Petition Number: 2025-025 General Location Identifier: 21902107

General Review Information

Local Residential Medium Street Typical Section (6' Sidewalk) CLDSM: U-02A

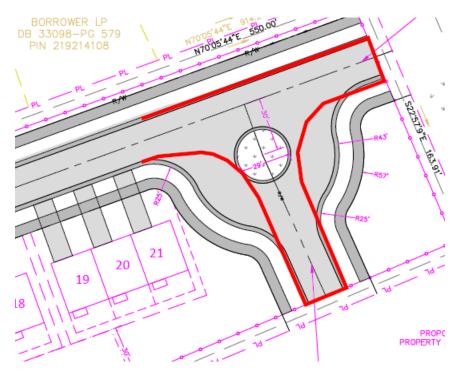
a. Loughlin Lane: Location of future back of curb and gutter is 13'.

Label and dimension the curb and gutter from the centerline for each road on the site plan.
